**Concept plan and Stage 1 Project Application
at Shepherds Bay Foreshore, Meadowbank
and Ryde**

MP09_0216 MOD1 and MP09_0219 MOD1

Secretary's Environmental Assessment Report
Section 75W of the
Environmental Planning and Assessment Act 1979

August 2014

Figure 19: Location of potential additional storeys on steeply sloping land (Base source: proponent's RtS)

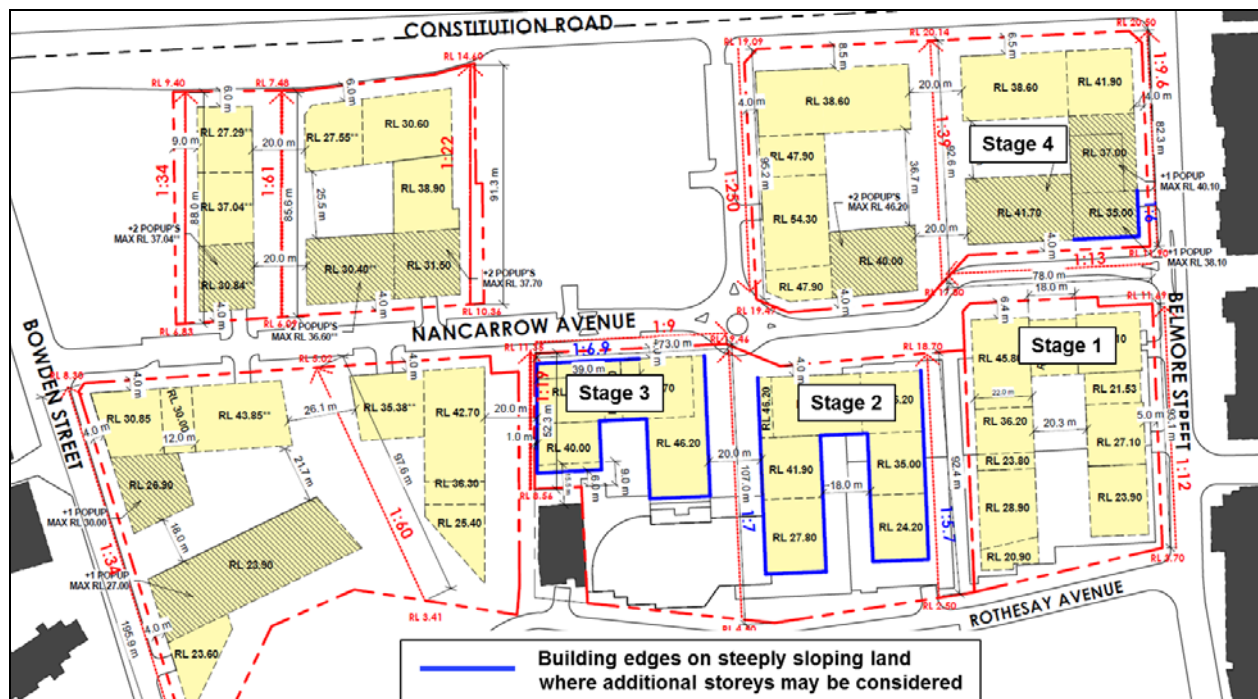
The proponent has stated that the matter of steeply sloping land and the associated design issues that impacted the approved elevations of Stage 1 will also be a problem for the remaining Stages of the concept approval. Consequently, to address this the proponent proposes a new FEAR that would (similarly to Stage 1) permit additional storeys at lower levels within Stages 2, 3 and (south eastern corner of) 4 on steeply sloping topography (no changes are proposed to the approved RL height for these stages). The building edges on steeply sloping land are shown in **Figure 19**.

- the provision of additional storeys would result in a canyon effect between buildings;
- the allowance for additional storeys results in an unrestricted and unpredictable increase in density; and
- the new apartments have poor amenity standards.

As discussed in the previous section, the department considers that the insertion of new apartments at the lower levels can be an effective solution to the issue of blank walls resulting from steeply sloping land. The department considers it reasonable that this principle be applied to

Figure 21: Location of basement car parking envelope expansions beneath internal courtyards and between Stages (Base source: proponent's application)

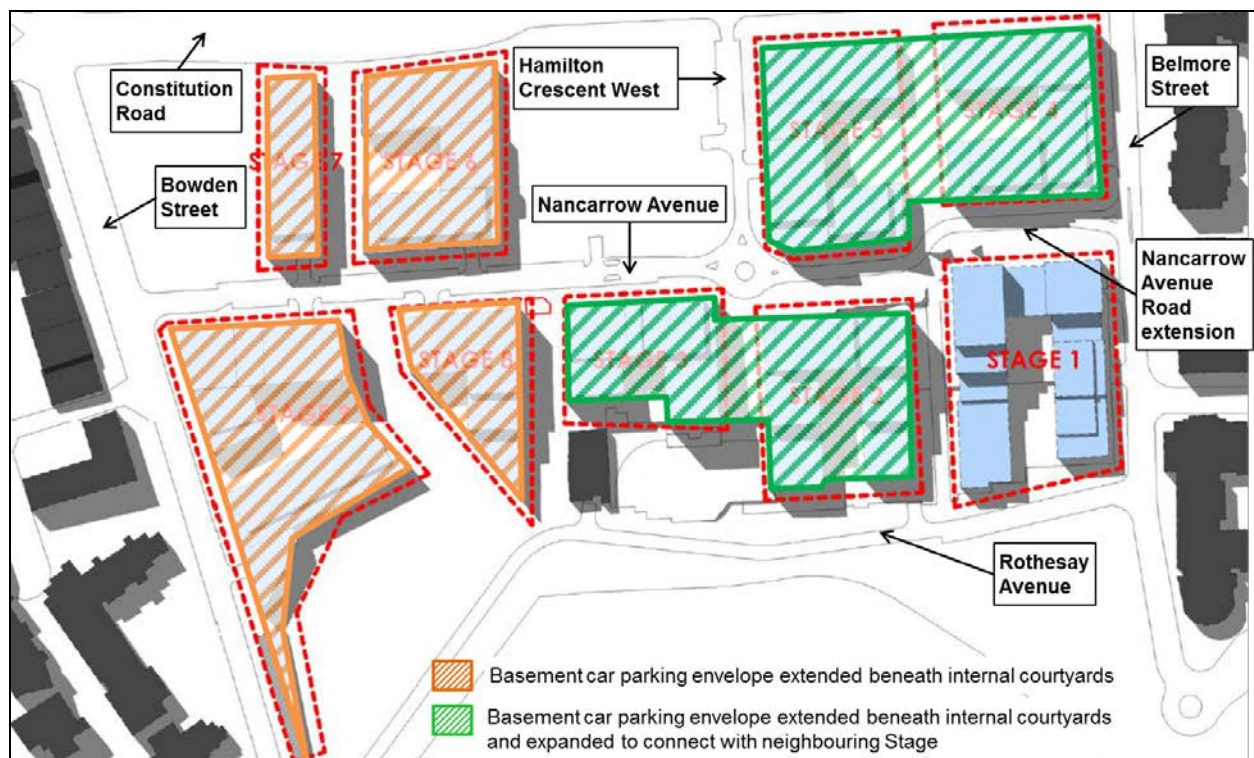
The concept approval allows for the construction of 12 building envelopes (within 10 Stages) that include basement car parking envelopes. FEAR 4 requires basement car parking envelopes to be located below building footprints and not to encroach into street setbacks. The proposal seeks to extend basement car parking envelopes beneath the central courtyards of the future buildings and expand and connect the basement car parking envelopes between Stage 2/3 and between Stages 4/5 (refer to **Figure 21**).

The department notes that the concept approval did not specify the location of deep soil planting areas. However, in response to Council's concerns, the proponent has provided an indicative landscaping plan (refer to **Figure 22**). The plan indicates the locations for deep soil planting areas, other landscaped areas and the varied soil depths that can be achieved in the case of the extension and connection of basement car parking envelopes.

Figure 23: Plan (left) and section (right) of deep soil and non-deep soil planting areas between the Stage 1 building and Nancarrow Avenue road extension (source: proponent's application and RtS)

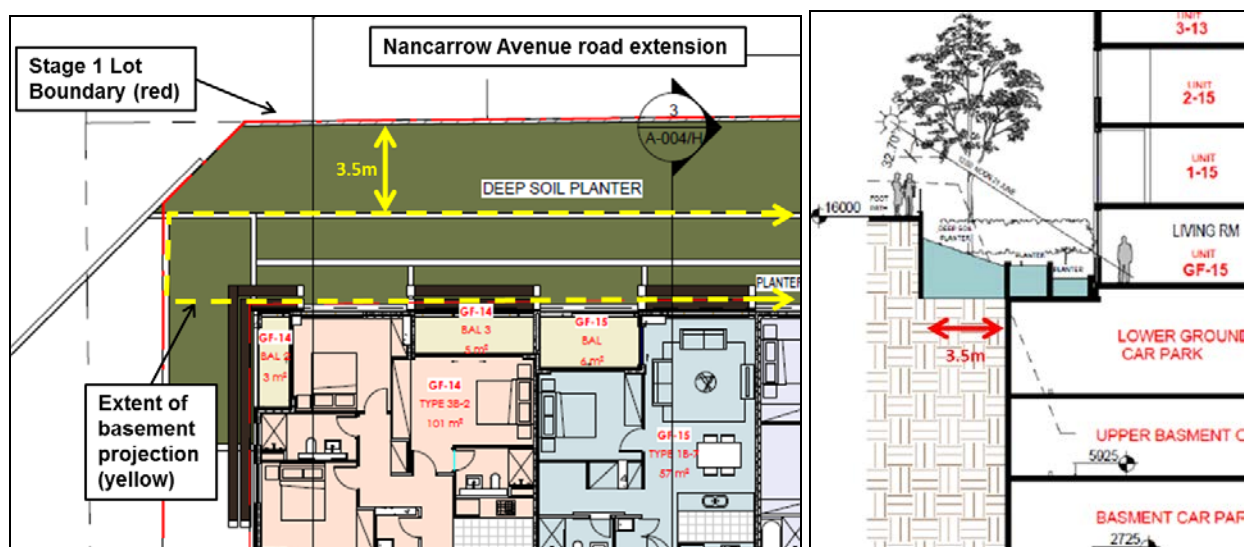
The proposal seeks to reduce the Stage 1 basement car park level setback at Hamilton Crescent / Nancarrow Avenue road extension from 6.4 metres to between 3 to 3.5 metres (refer to **Figure 23**). The proponent has stated that the alteration would allow for improved circulation and parking arrangements and the inclusion of lockable storage areas.

Council has objected to the proposed expansion of the basement envelope and consequential reduction of setback to Hamilton Crescent due to the reduction of deep soil planting area. Furthermore, Council is concerned that as the Nancarrow Avenue road extension design has not yet been agreed (condition B29), the extension of the basement car parking envelope could impact on future road design and delivery.

In response to the department's request for further clarification of the impact of the expansion of the basement northwards, the proponent has provided information confirming that a minimum width of only two metres is required to sustain street tree planting (refer to **Figure 24**) and therefore an appropriate level of sufficient deep soil area, as proposed, is provided.

- although the width of the deep soil planting area is restricted to 3.5 metres, the length is uninterrupted for 31 metres and therefore allows for the lateral root spread of future trees;
- when compared with the approved scheme (refer to **Figure 18**) the proposal results in an overall increase in soft planting area and the removal of hard-paved circulation space; and
- the non-deep soil planted area located above the basement extension would achieve soil depths of between 450mm to one metre, which will provide for a vegetated buffer that complements the planting in the deep soil zone.

The department considers that as a landscaped buffer is retained between the road and the extent of the basement it is unlikely that the enlarged basement would have an adverse impact on road design. Further detailed discussion on the Nancarrow Avenue road extension is provided at **Section 5.7.3**.

Figure 26: Excerpt of the approved indicative staging (left) and proposed indicative staging (right) (source: concept approval and proponent's application)

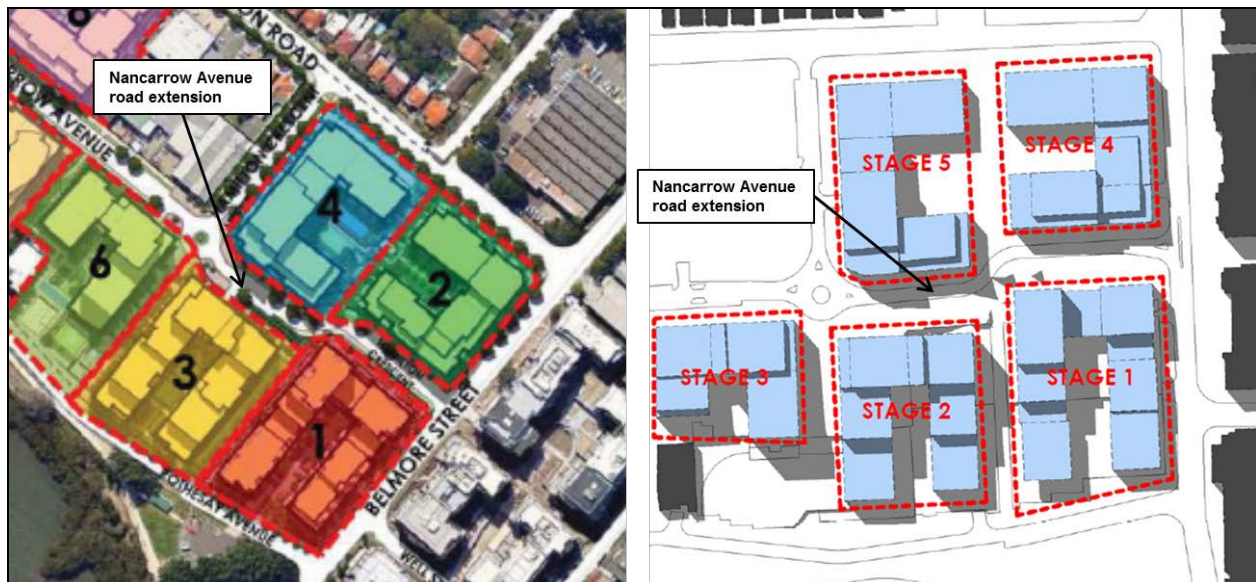
The proposal seeks to change the timing of the delivery of the road upgrade works required by FEAR 24 from approved Stage 2 to proposed Stage 4 and FEAR 25 from approved Stage 4 to proposed Stage 5 (refer to **Figure 26**). The proponent states that the amendment would allow for a more logical and efficient construction process.

The Council has objected to the delay of the road upgrade works to Stage 4 stating that there is a risk that insufficient space will be reserved for the provision of the new roads (as a result of the development of proposed foreshore link and basement level of Stage 1). Council also noted that there may also be interface issues between future buildings and the roadway.

The department notes that the proponent has provided supporting traffic and civil engineering advice, which confirms that the road reserve footprint provides sufficient space to allow for the construction of the future road.

Figure 20: Excerpt of the concept approval RL Heights Plan, the Constitution Road and Belmore Street corner building circled in red (Base source: the concept approval)

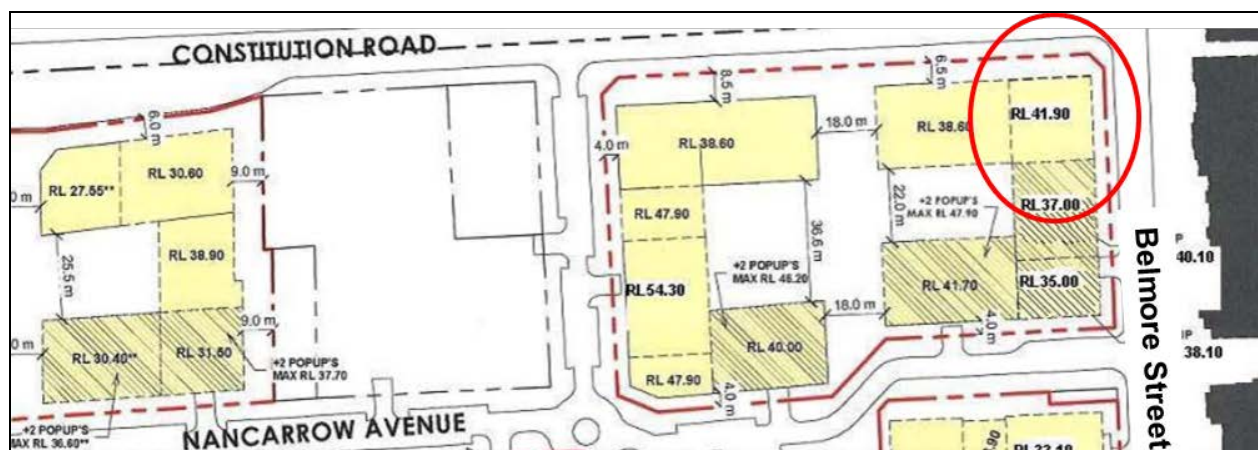
- the Storey Height Plan restricts the corner building to a maximum of six storeys (refer to **Figure 4**); and
- FEAR 3 restricts all buildings along Constitution Road to five storeys.

Council has objected to the provision of a sixth storey on the corner building stating that the corner nature of the building and its relationship to the street can be addressed through building articulation and architectural treatment within a five storey envelope and does not necessitate an increase in height.

The department notes the inconsistency between the Storey Height Plan and FEAR 3. However, the department is satisfied that it was the intention of the determination to allow for a six storey building in this location, as an increase in height at the corner is corroborated by the Maximum RL Height Plan (refer to **Figure 20**). Furthermore, the department notes that the buildings on Belmore Street opposite the proposed corner building are 6 storeys in height and therefore the provision of a six storey building in the proposed location is acceptable in this context. The department recommends that FEAR 3 be amended accordingly.
